KA Sail Australia a division of Kingston Range Pty Ltd

WASZP upgrades

Andrew McDougall, December 2017

Wing Tube Sleeves

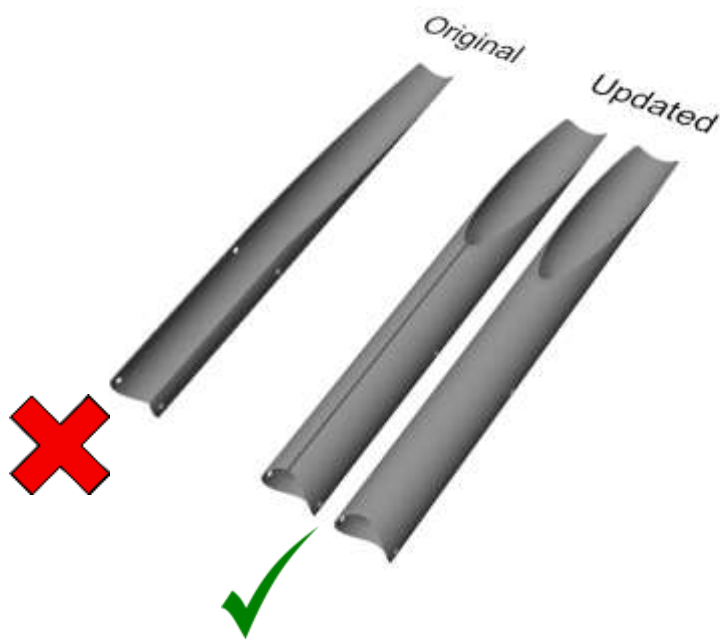
The original sleeves strengthening the front and rear wing bars only wrapped 70% the way around the wing bar. We found that under high hiking loads the sleeve could crack allowing the wing bar to bend or even fail. We have developed new wing sleeves which fully wrap or have a small slot. If you have the original with the 70% coverage please choose the upgrade. Please also check if any of your main wing tubes are bent. If so select the tubes you need from the main webstore and select 'Submit to KA' on checkout so that we can adjust the price to zero.

Bolt Rope Track

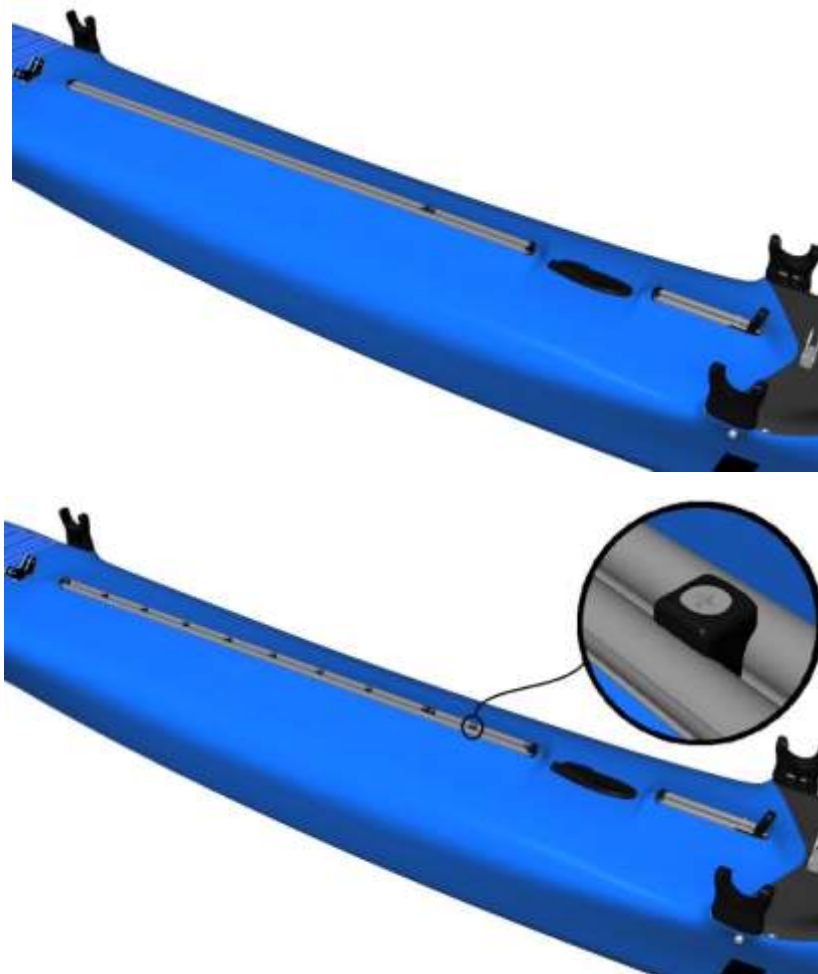
In early boats (pre ~2160) this bolt rope track was not bedded down on a raft of Plexus glue. This allowed the track to move and possibly break the M3 bolts holding it down.

The solution is to upgrade bolts to 4mm with a plastic insert to spread the load on the bolt.

- If your boat # is higher than 2160, it is only a precaution. No action is OK.
- Install the new bolts and inserts yourself and receive a \$50 credit on our web store (or with local agent) – see video [Bolt Track Upgrade](#). Tools are provided in the kit but you will need a cordless drill with Phillips #1 and #2 screw driver bits.
- If you are not comfortable with doing it and your boat # is below 2160, please get a quote to get it done for you and submit a warranty claim:

Ride Height Adjuster Update

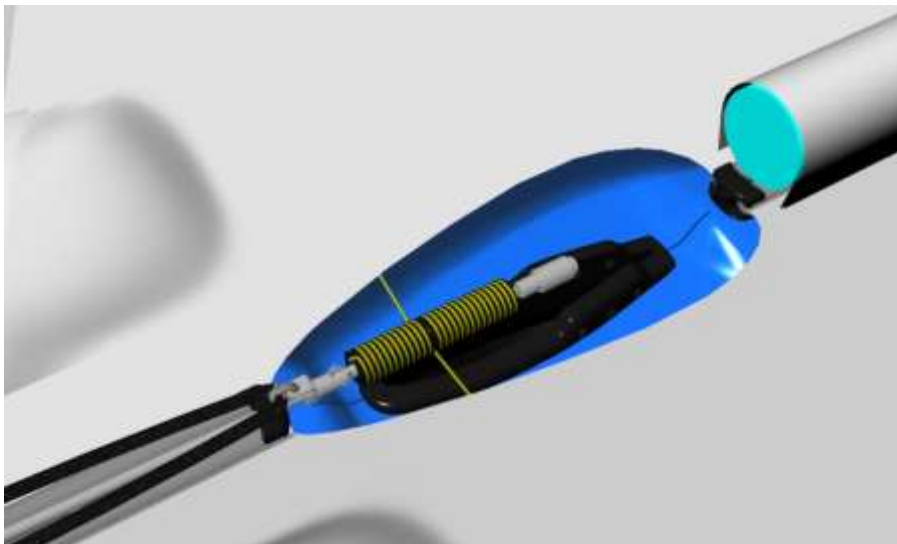
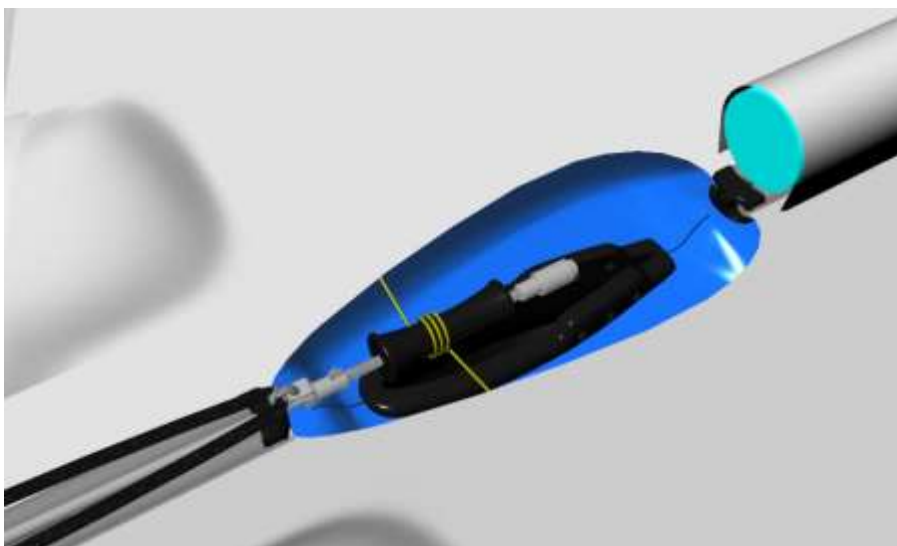
The first item that started to fail was the original ride height adjuster. Initially we re-engineered the part with a single internal bush rather than the split one which could have the right height adjuster to breaking in half. In tandem with this we decided to completely redesign the right height adjuster to make it much easier to use forming a more inverted barrel shape. So: - if you have the ride height adjuster as shown in this photo we can send you the new style. Some people actually prefer the old style as it gives you a better visual feedback of where your right height is. Personally, I like the new one as it is less likely to tangle than the old one. See video [RHA_V2](#)

If it has not broken you may want to keep with it, even so we can still send you the upgraded version

Ride Height Adjuster Update

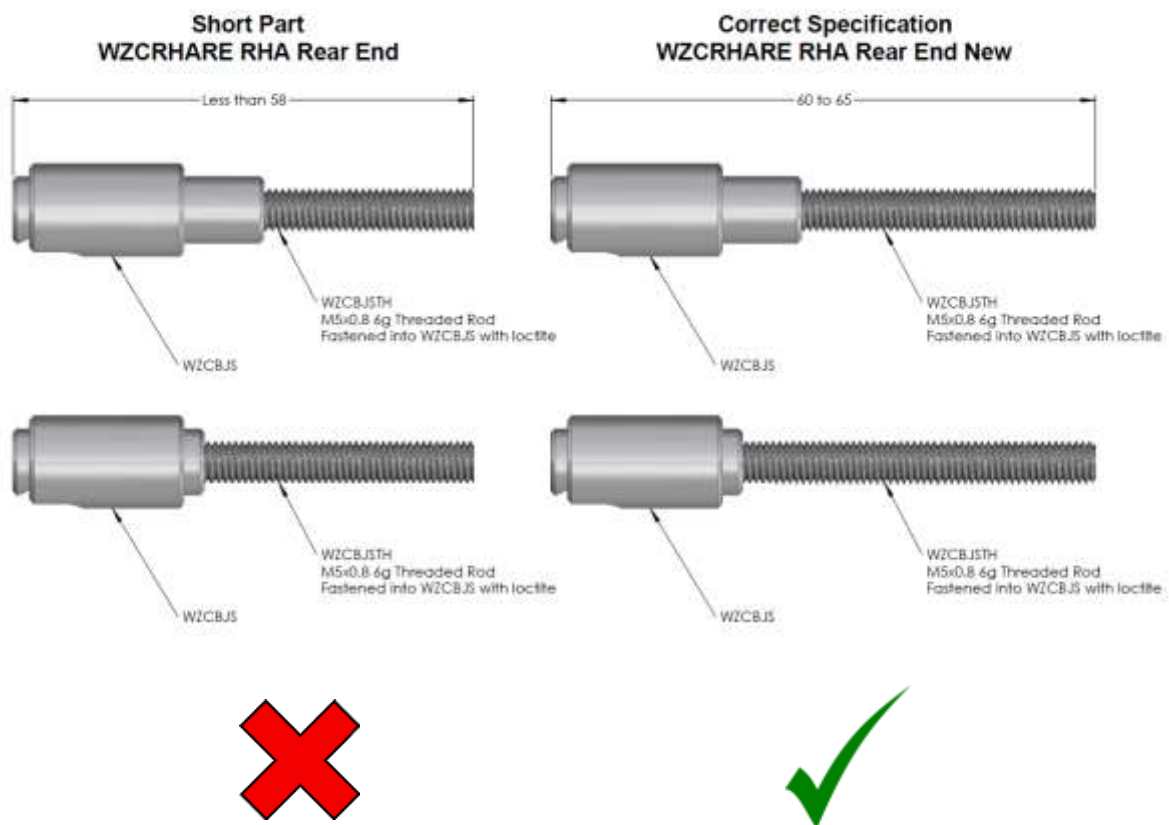
The new ride height adjuster created another problem: some were provided with the ball joint socket (shown here) being too short and there was not enough range in the right height adjuster (sometimes resulting in losing the right height adjuster barrel). If the total length of the supplied RHRE part is less than (<) **60 mm**, please select the new RHA Connector pack to extend this part to the correct length.

Note there are two types of socket heads, both are OK.

Adjustable Push Rod

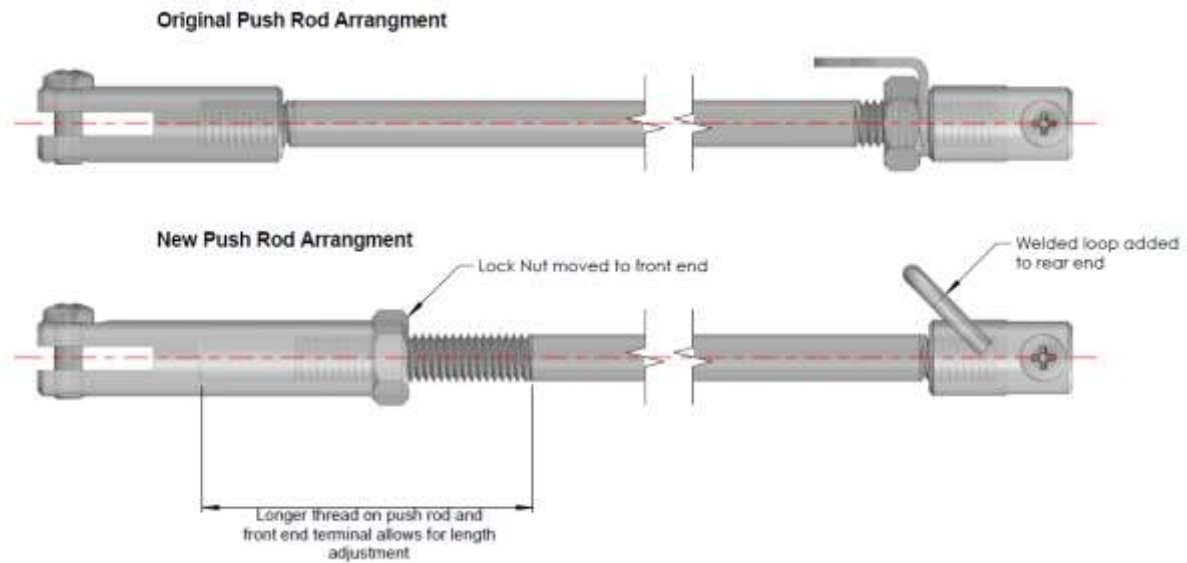
We found that there were variations in the boat and parts, enough to cause the wand to not to be able to actuate the flat in the correct range, making the boat difficult to control. To get around this issue we have a new push rod and ends, which allows for full adjustment to get the setup right. See Video [Push Rod Upgrade](#)

Wand Control Link

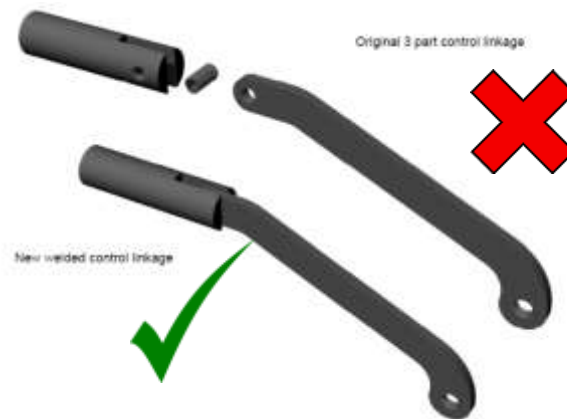
There have been issues with a grub screw joining the wand link to the slider just behind the wand. This could come out and cause the wand to be restricted and causing control problems. It also can dislodge the slider casing from the boat. The new slider has a welded pin that cannot cause any problems.

Please check that your slider casing is still securely glued in place: Add it to your order if not.

Gearing Setting

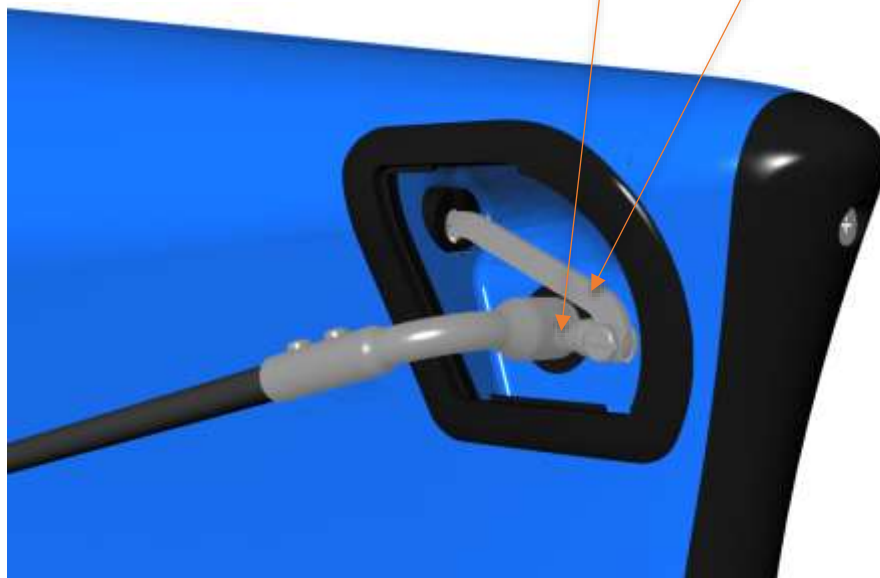
Some of the problems have been due to the factory gearing setting wound out too far, stressing the system. Please reset this to a maximum of 4 turns out (This was listed as 8 turns in earlier instructions). As you get more skilled wind the adjustor in to almost 0 turns, unless you're sailing in extreme wave conditions.

I also want to talk about how to attach the gearing adjuster to the wand link. As the two halves of the fork on the adjustor and the wand link all are threaded, it is important to pull the wand link outwards until the link is against the inside of the fork on the adjustor. This is so that the fixing screw picks up the thread in the wand link plate immediately the screw emerges from the outer half of the fork, before pushing it to the other side.

If the link is jammed on one side it can cause the wand not being able to extend forwards. Note that both parts have a thread which has allowed us to make the components small and tough but do require a little bit of thought when assembling. See video [Pullrod System Upgrade](#).

Wand Limiter

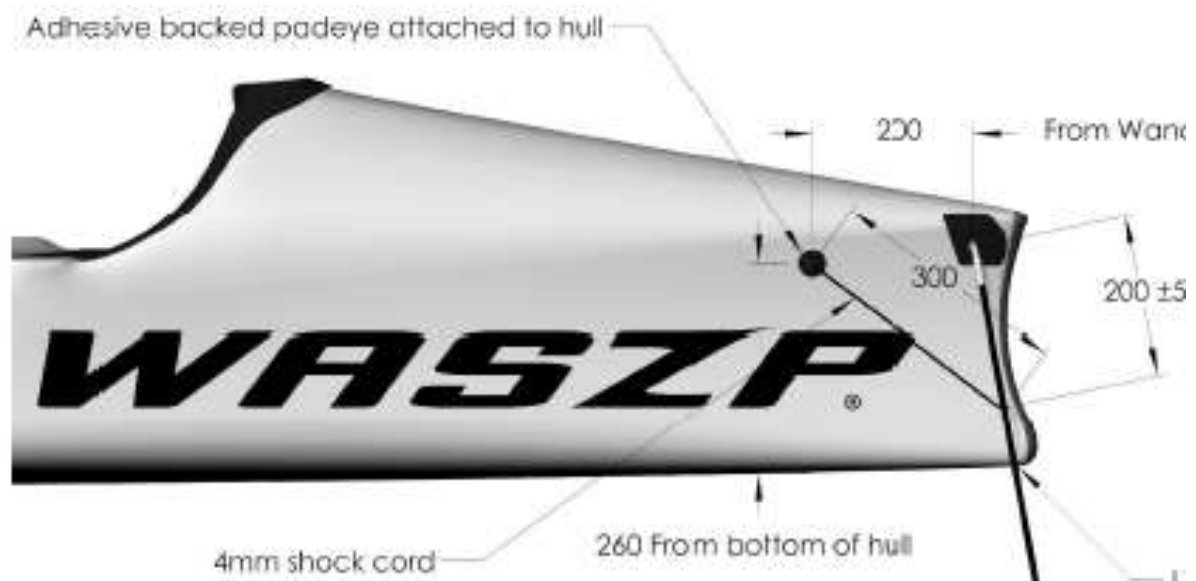
With all the tweaks we are doing, the wand should flick forward easily, which is great for waves and strong winds, but not so great at other times. We have included the tether and bungy. The limiter allows you to adjust the flick by sliding the bungy along the wand shaft.

Bell crank axle working out of the front vertical foil

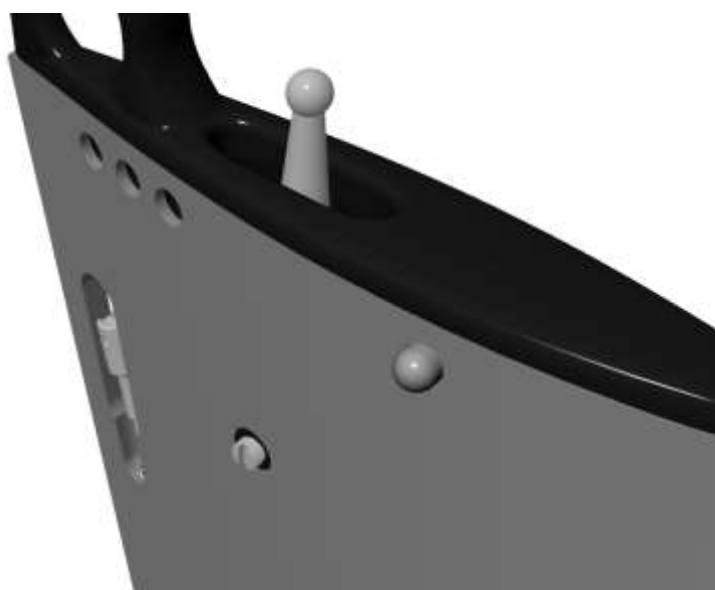
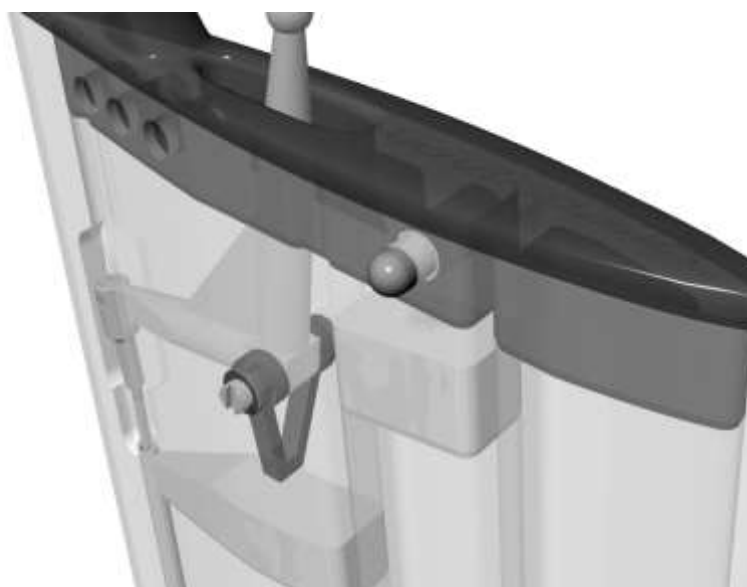
It is possible that the Bell Crank Axle could work out causing poor operation of the flap and also difficulty getting the foil out of the case. We have now changed the Loctite specification that is used to 680 - a high strength Loctite specifically designed for plastics. A reasonable solution is to use superglue if you discover the Bell Crank Axle is loose. If you find that the thread has been stripped in the plastic that the Bell Crank Axle sits in, please select this in the webshop with your upgrade pack.

Lost / Damaged grub screw in foil push rod top terminator

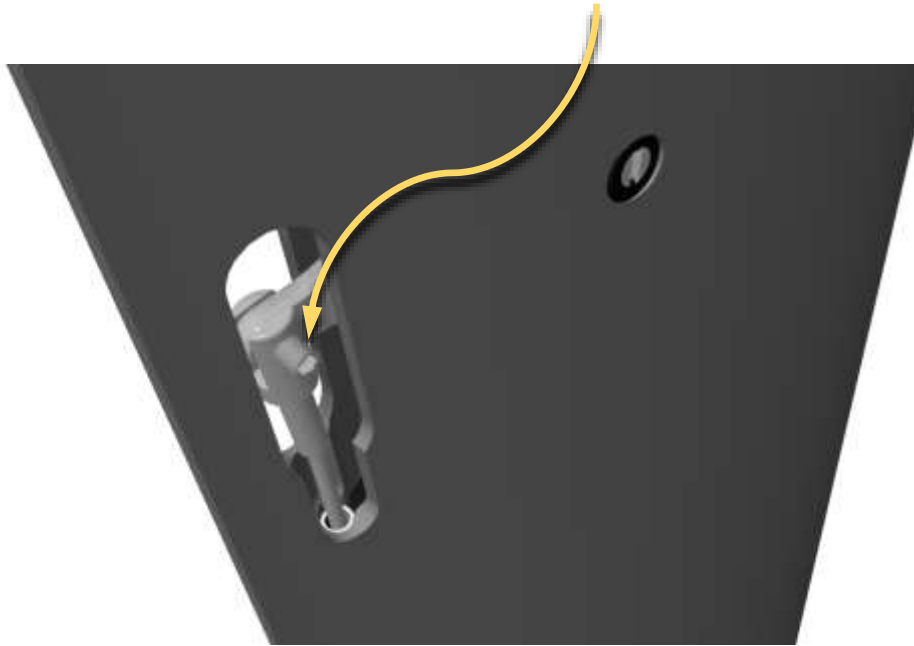
When assembling the front foil, it is easy to lose or damage the grub screw. We are updating our instructions to show a way to assemble without removing this. See video [Front Foil Disassembly](#). If you do remove the grub screw, don't use force to put it back in as both parts have threads it needs care to line up.

Image showing additional holes to inject spabond.

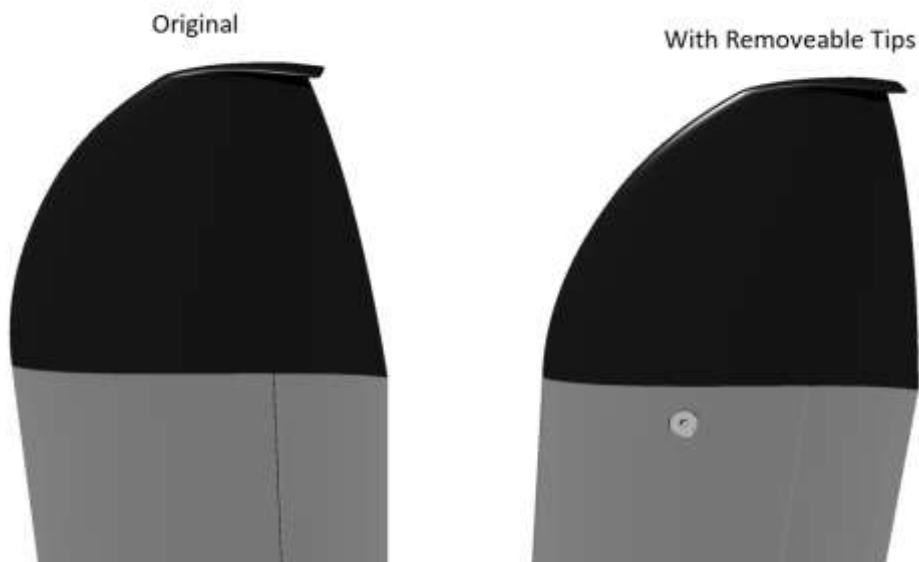
The barrel nut is a small metal part inside the front foil flap that connects the pushrod to the flap. The design is the same as what had been used successfully in the Mach2 for many years. We discovered that the openness of the aluminium section used in the WASZP allowed the barrel nut to bend and sometimes break, resulting in the pushrod pushing through the bottom of the flap. There have been two stages of addressing this problem: The first was to inject the area with glue to encapsulate the barrel nut, the second stage, coming online now, has been to create a new extrusion die for the flap that encapsulates the barrel nut completely. This new section has been coupled with rethinking the tip attachment so they can be removed and replaced more easily. It also allows replacement of the barrel nut. If your foil does not have two injection holes near the barrel nut or screw holes near the tips that signify the tips are removable, then the barrel nut has a possibility of failing.

1. Leave it. If it fails we will repair or replace. We extend the warranty on this part to 3 years.
or
2. Receive an AU\$50 credit on the web store if you inject the foil yourself. (Upload a pic of the injected glue, before trimming, in a warranty claim). Video: [Barrel Nut Injection](#)
or
3. Buy the new specification foil for 40% off for a limited time.
or
4. Not practical for the majority of locations – to get the foil back to our main offices for injection (Melbourne Australia or Lugano Switzerland. More options may come available).
